Building Code of Australia 2016

Report for BCA Compliance

PROJECT NAME: The University of Sydney – Chau Chak Wing Museum Project

DATE: 30 March 2017

Figure 2 – Concept section - CCW

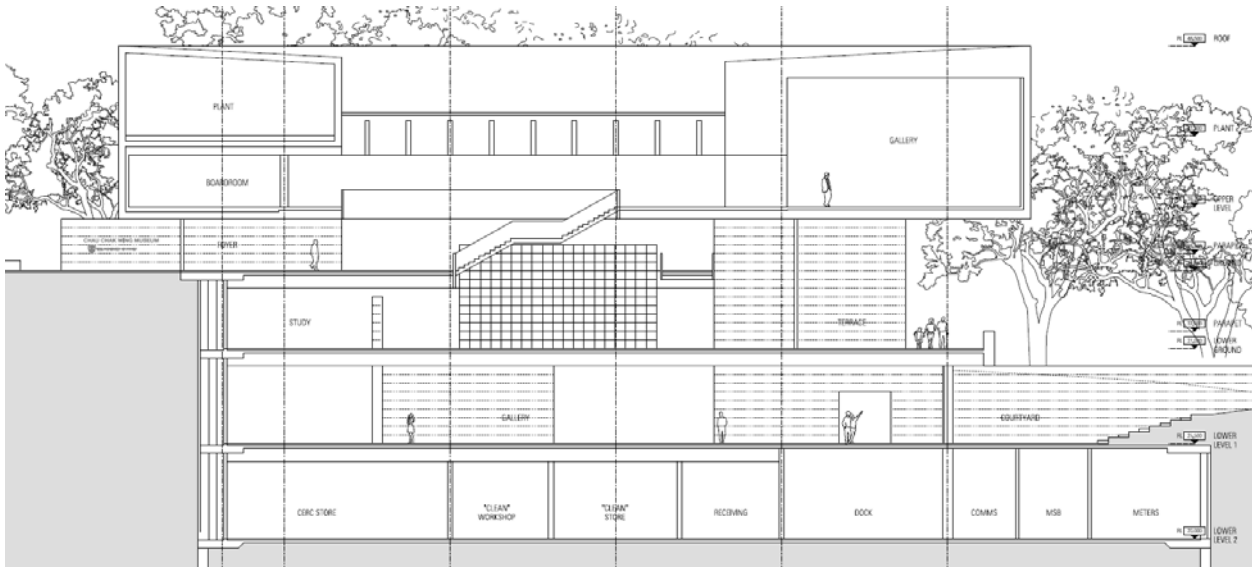
Note*: The effective height has been taken from the lowest level at Lower Level 1 (25.5RL) to Upper Level (39.2m). The Workshops, Loading Dock & cafe have been considered as ancillary to the major Classification of the storey in which they are located due to their floor areas being less than 10% of that storey.
